Project Name:	Elm Grove, Hayling Island
Document Reference:	143.007/TN/1
Document Name:	Technical Note
Prepared By:	Rob Hardyman (June 2020)
Checked By:	Mark Smith (June 2020)
Approved By:	Mark Smith (June 2020)

1.1 This Transport Note (TN) has been prepared by Paul Basham Associates on behalf of Hamlets Homes to address the comments raised by Hampshire County Council (HCC) in response to application reference: 20/00015 for the demolition of the existing vacant retail units and construction of 1no. retail unit, 4no. one-bedroom flats and a 39-unit assisted living accommodation at 108-110 Elm Grove Hayling Island.

108-110 Elmgrove, Hayling Island PO11 9EN

Figure 1: Pedestrian PIA Data (2015-2019) obtained from Crashmap.co.uk

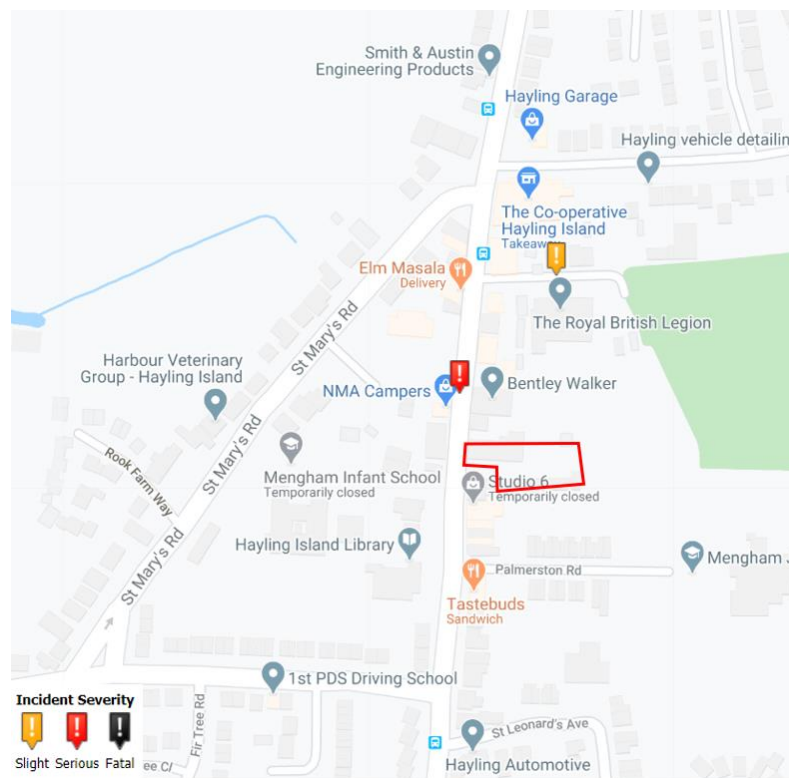
- 2.1 HCC have identified that they require further analysis of the PIA data which was reviewed as part of the Transport Statement. From discussing this with HCC, it is understood that review of the pedestrian accidents is required. The data available from Crashmap for the period between January 2015 to December 2019 has therefore been interrogated, focussing only on pedestrian accidents. There have been two pedestrian accidents (one slight and one serious) within this timeframe.

Given the proposed form of development, the Highway Authority requires an analysis of the accident data to identify the nature of the accidents along Elm Grove.

- 2.2 The serious accident occurred on Elm Grove at the location of the zebra crossing, occurring in 2017. The alignment of Elm Grove is straight and therefore benefits from excellent intervisibility between pedestrians and road users at the crossing. Therefore, this incident appears to be an unfortunate occurrence and not one that could be attributed to deficient highway design.

- 2.3 The slight accident occurred on Legion Road, approximately in the location of the junction with Gable Mews (a private road) in 2016 Legion Road is a cul-de-sac, which serves the British Legion, Gable Mews and parking for retail units and allotments. The location at which the accident occurred benefits from good forward visibility for vehicles on Legion Road. This therefore again appears to be an unfortunate incident rather than substandard highway design.

- 2.4 Further to the above, the assessment of the PIA data needs to be considered in the context of the scale of the development proposal. Whilst the two incidents outlined above were unfortunate, they do not identify a pattern which would be exacerbated by the proposed development. This is pertinent as the proposal will result in a reduction of vehicle trips on the highway network when compared to the existing use of the site, which could be brought back into use without planning.

- 2.5 In summary, whilst the two pedestrian accidents are regrettable, their occurrence would not increase as a result of the development proposal.

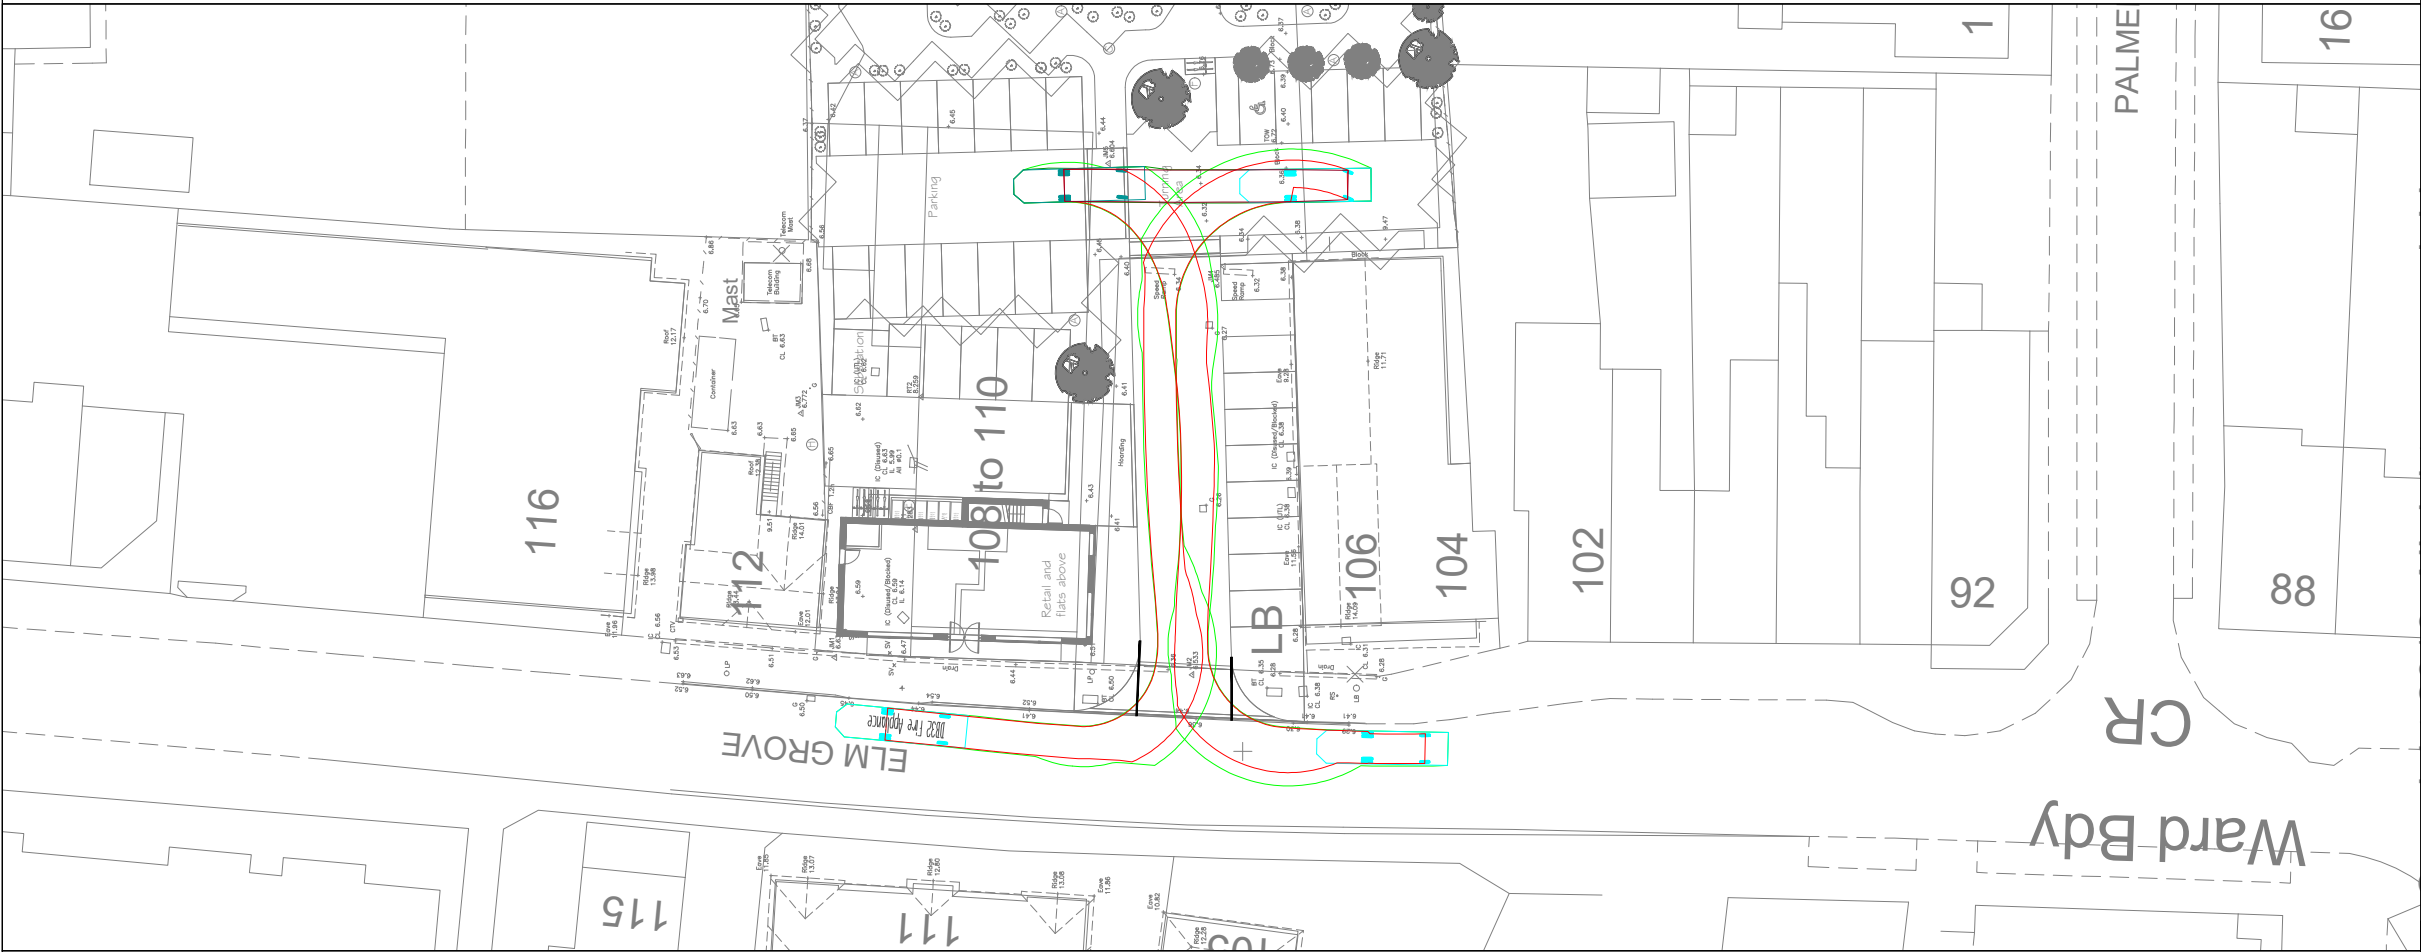
To formalise this arrangement, dropped kerb should be provided across the entire length of the access and constructed to an appropriate standard to accommodate HGV movements. Swept path analyses will be required to demonstrate that a refuse vehicle can safely enter and exit the site in a forward gear and two family cars can safely pass. Visibility splays for vehicles and pedestrians are also required.

- 3.1 HCC have requested that the access into the site from Elm Grove is retained as a vehicle crossover, rather than provide a simple priority junction as proposed in our Transport Statement (ref: 143.0007/TS/2).
- 3.2 The revisions to the access arrangement are illustrated on drawing number 143.0007.001A included in **Appendix B**. The swept path analysis for a refuse vehicle and two large cars is illustrated on drawing number 143.0007.002B and 143.0007.003 included in **Appendix C**.

- 8.3 The proposed site access arrangements have been amended to provide a vehicle crossover rather than a simple priority arrangement. Swept path analysis demonstrates that the access can accommodate the turning movements of a refuse vehicle and two large cars.

PRIVATE VEHICLE AND DELIVERY VEHICLE TRACKING

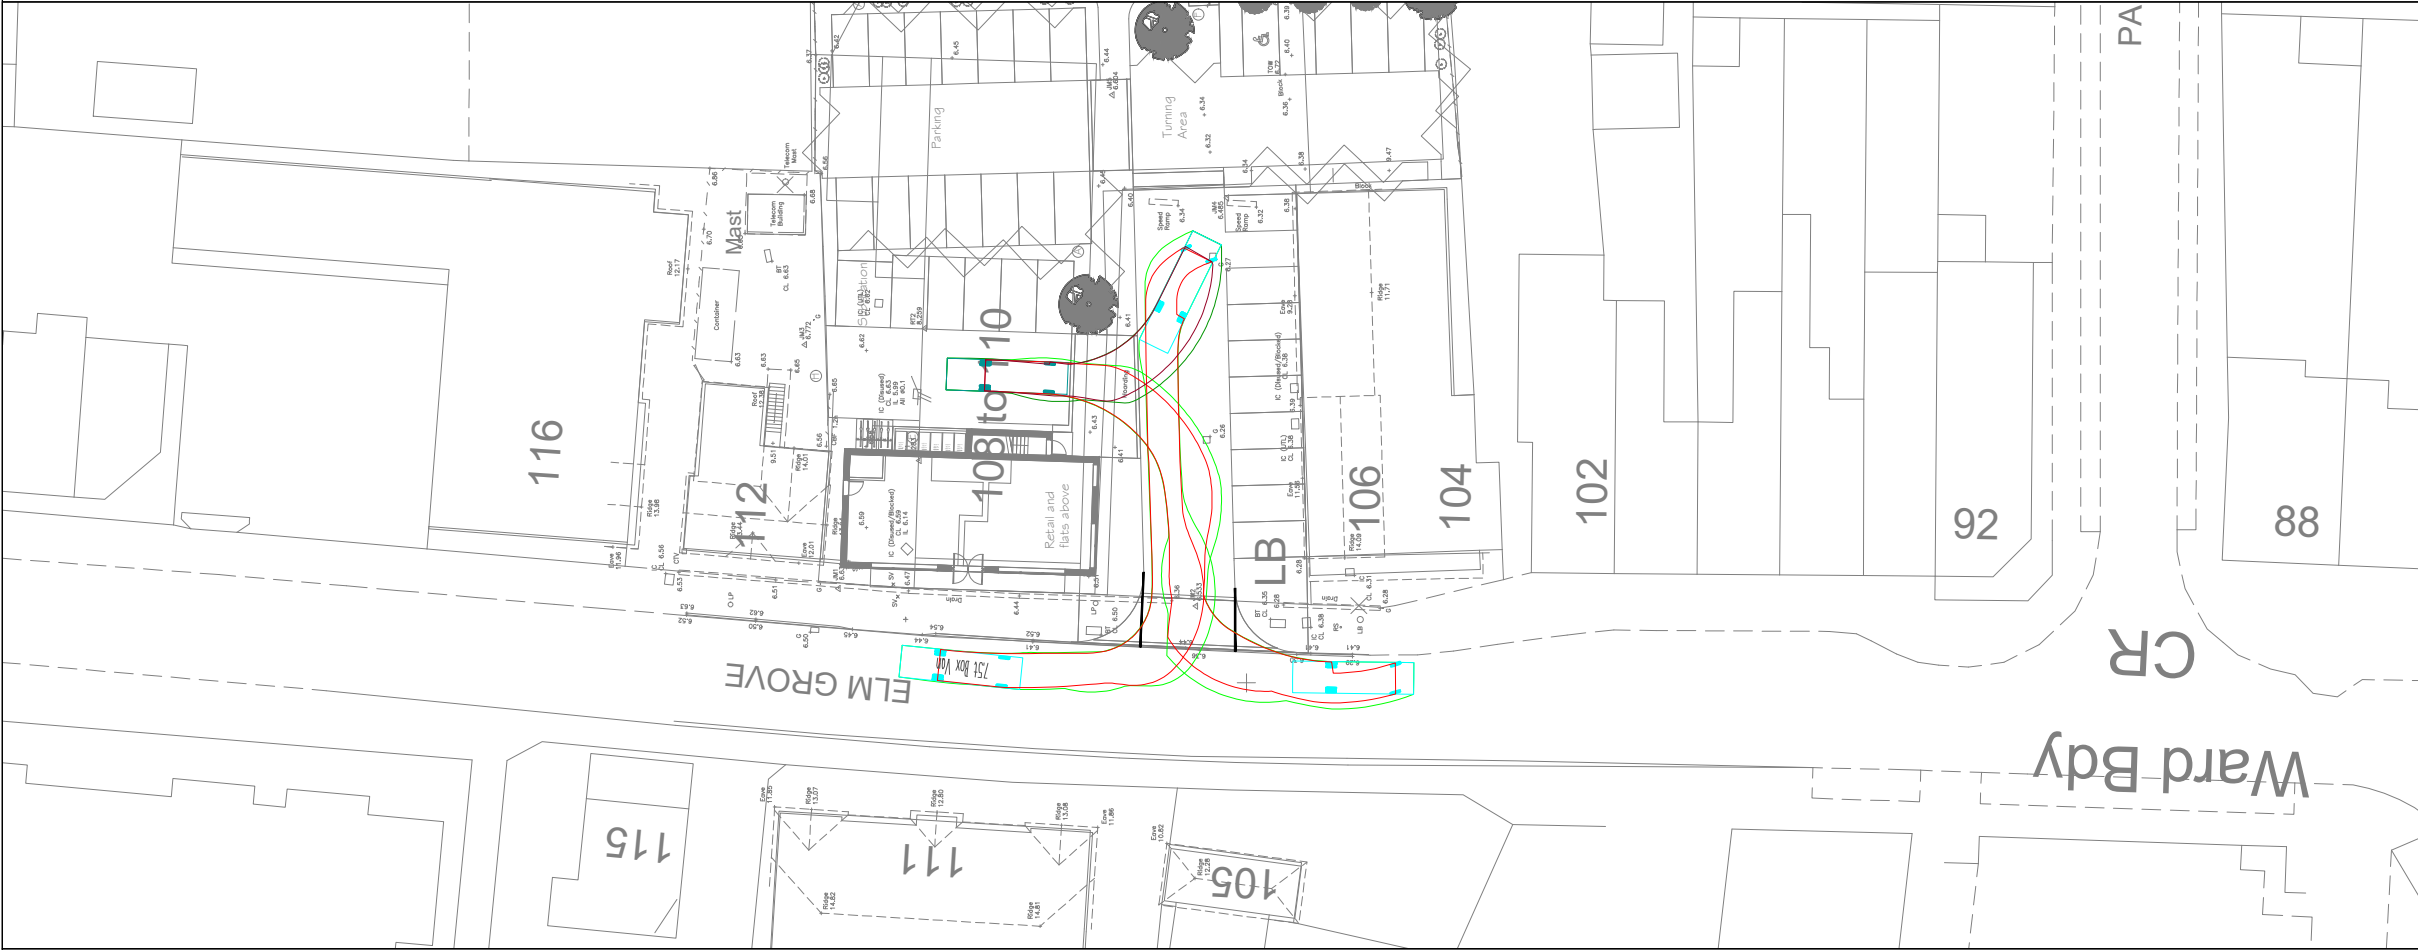
Confirmation is also required from the applicant as to how deliveries will be made to the site in the absence of visitor parking bays and/or a dedicated servicing area for the assisted living units and retail area.

- 6.3 Further swept path analysis has been undertaken using a rigid HGV and it is demonstrated that this could enter into the retail area and turn to exit the site in forward gear. This is illustrated on drawing number 143.0007.003 included at **Appendix C**.

- 6.4 As noted above, the servicing requirements will be subject to the end users and therefore it is recommended that a suitably worded pre-occupation condition is attached to the planning permission to require the submission of a servicing management plan for the assisted living units and retail unit.
